Re: APP/17/01089 - Erection of 1No. 5 bed dwelling.
11 Warblington Road, Emsworth, PO10 7HE

I am writing to you to comment on the above planning application. I agree with the points identified by the Planning Department in their pre-application advice, but make further comment as follows.

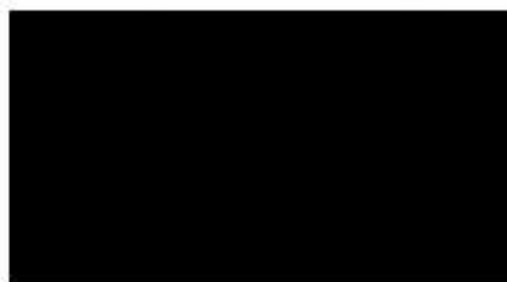
The proposed development is significantly forward of the existing consistent building line. The layout of the surrounding area has the dwellings on both sides of Warblington Road set consistently at 45 degrees to the line of the street boundaries. This arrangement of a natural stagger to follow the line of the road contributes to the special and spacious character of this area. The SPD states: "The special character of Warblington Road should be preserved and maintained" and "minimise the visual impact of new buildings". The proposed dwelling is not at 45 degrees.

Note that, on the location plan within the application for No11, the building apparently forward of the building line at 10 Warblington Road does not exist.

impression of bulk, given its spacing back from the street boundary and the adjacent area of garden to the east. The proposed new dwelling appears from the plans to have a similar bulk to the existing dwelling. The orientation of the new dwelling in the proposed site plan takes its north-west corner towards the line of the two storey gable of the existing dwelling, thereby reducing the spacing to a gate width, as seen from the street view. The two properties so close together will give an impression of significant bulk and does not reflect existing spatial characteristics. The proposed dwelling does not "minimise the visual impact of new buildings". The introduction of the mass and bulk of the proposed five bedroom house in such a forward position and in such close proximity to its neighbour is considered overbearing and will have a detrimental visual impact on the street scene.
